4.0 REVISIONS TO THE DEIS/DEIR

Changes to the text of the Phase 3 DEIS/DEIR are shown in this chapter, in page order, with a line through the text that has been deleted (~~strikeout~~) or underlining where new text has been added.

PAGE H-7

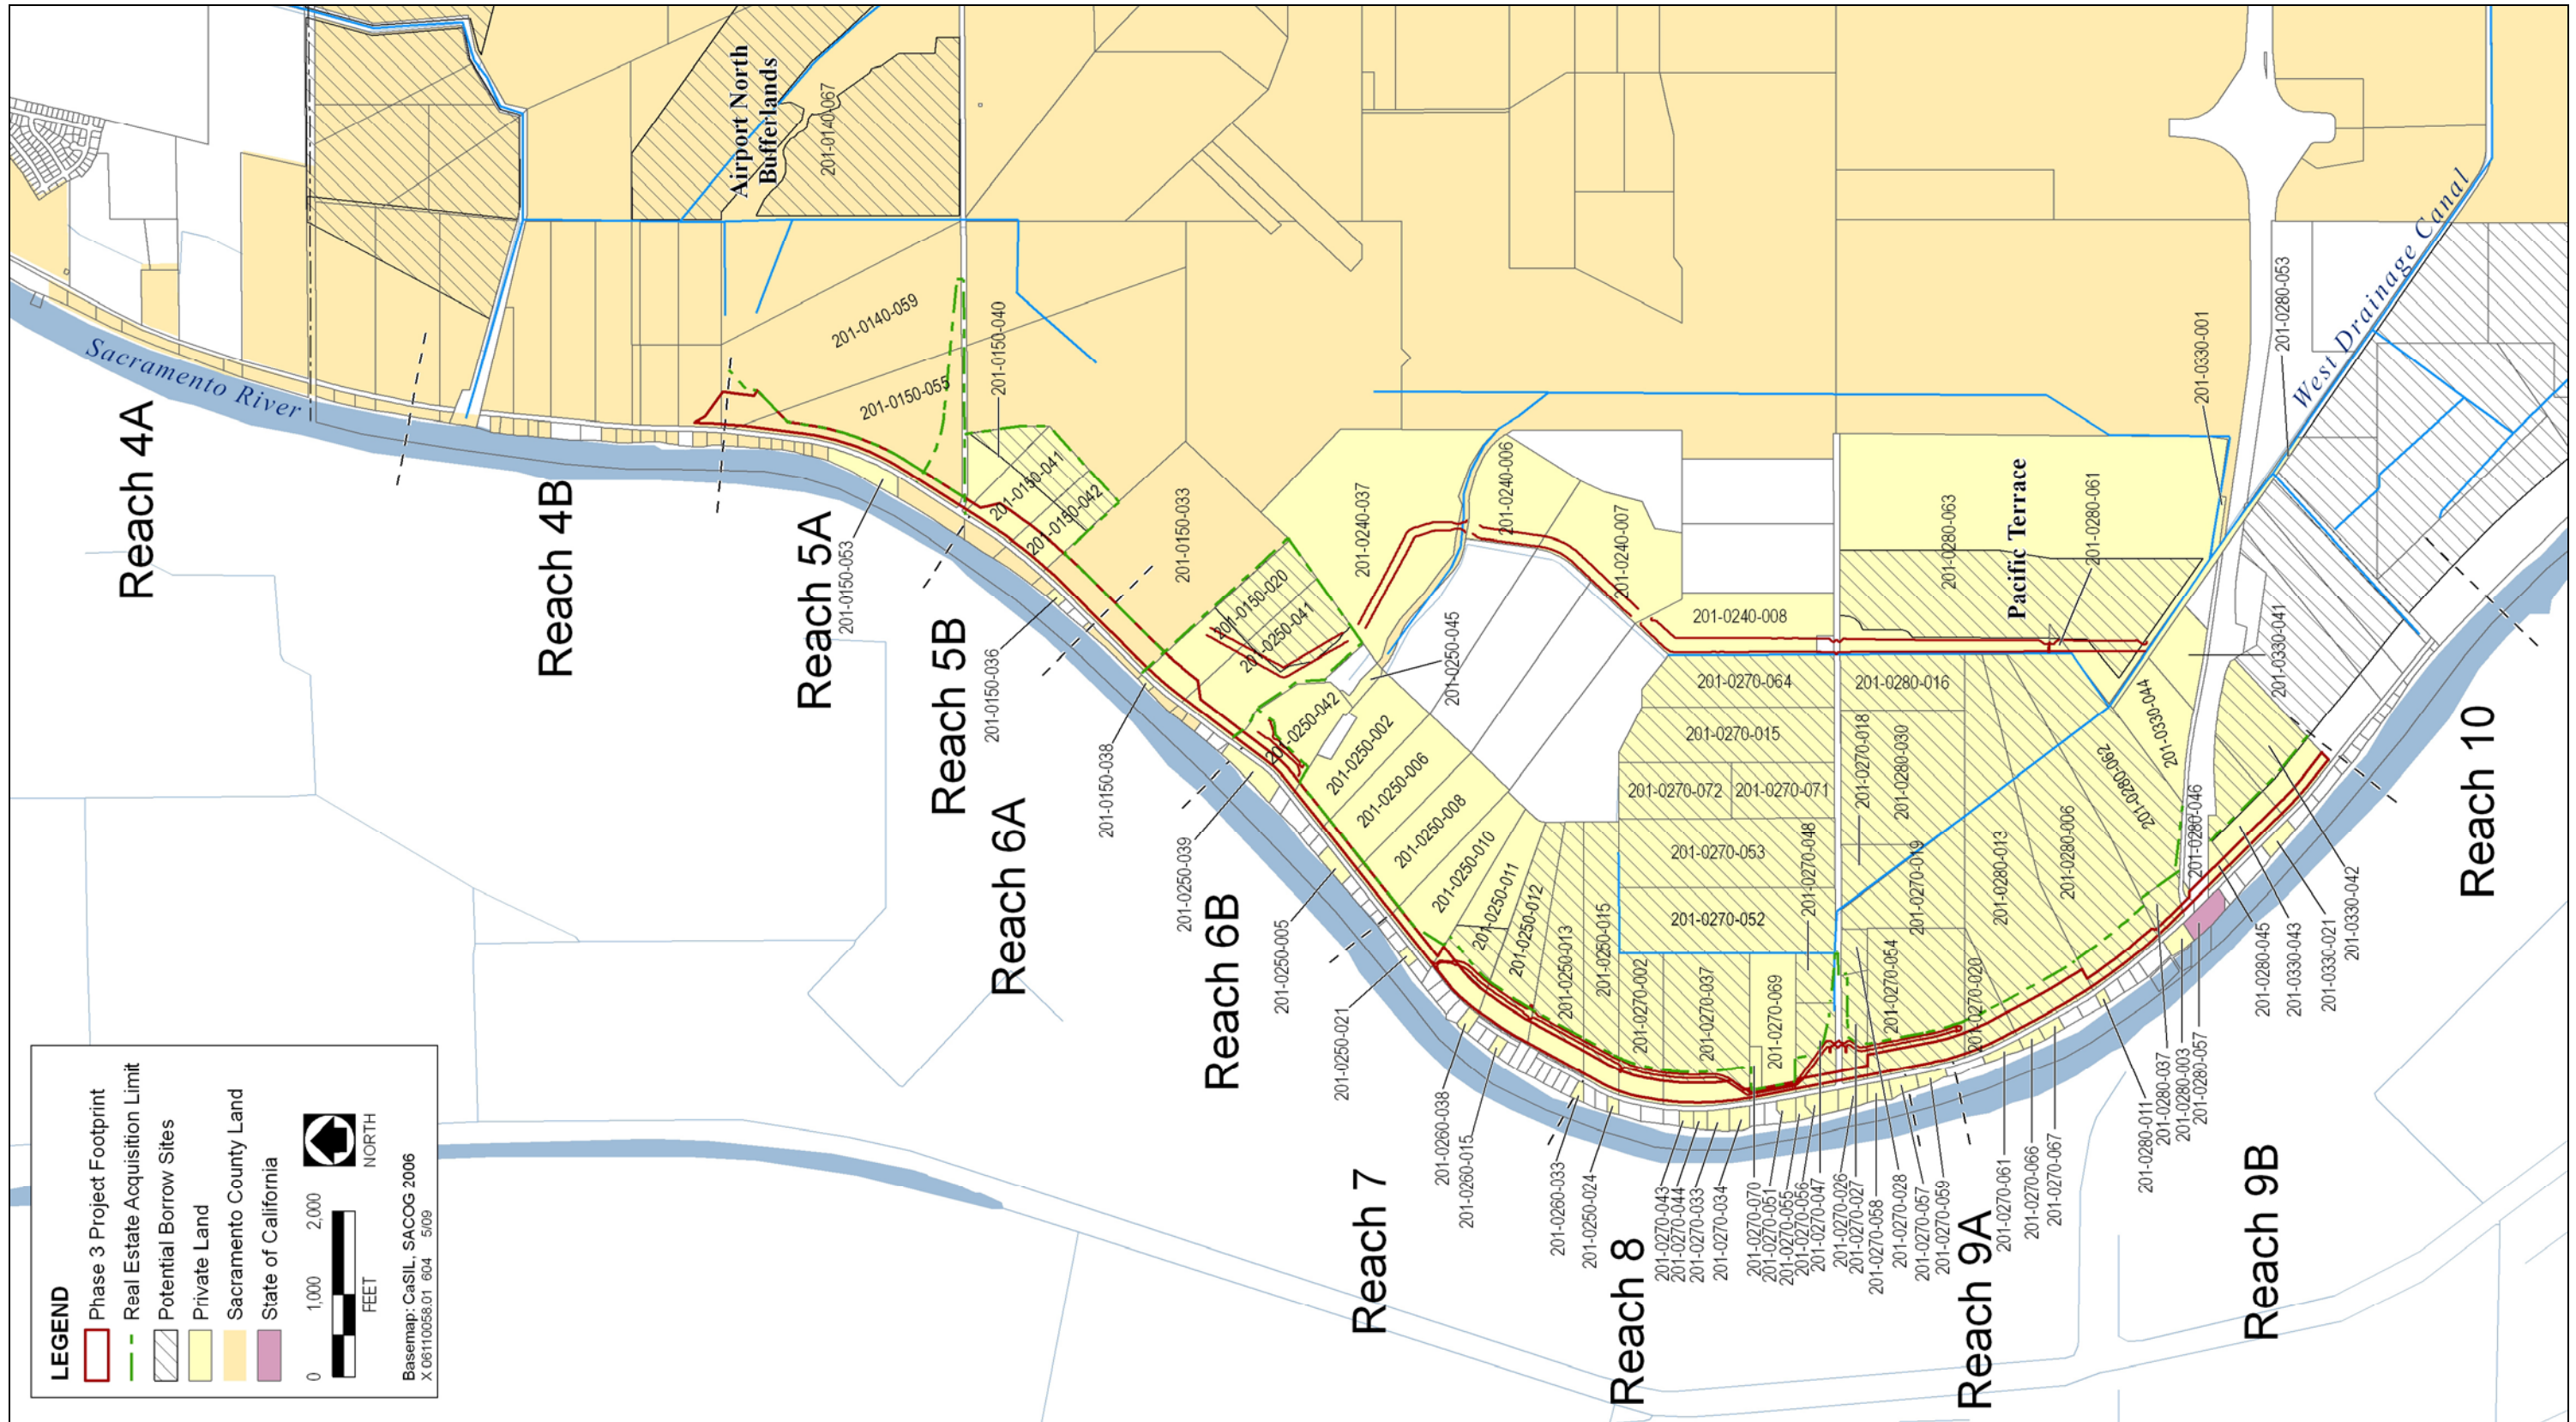
To clarify which parcels would be subject to real estate acquisition under the proposed project, Exhibit H-1b has been revised to show a maximum real estate acquisition limit.
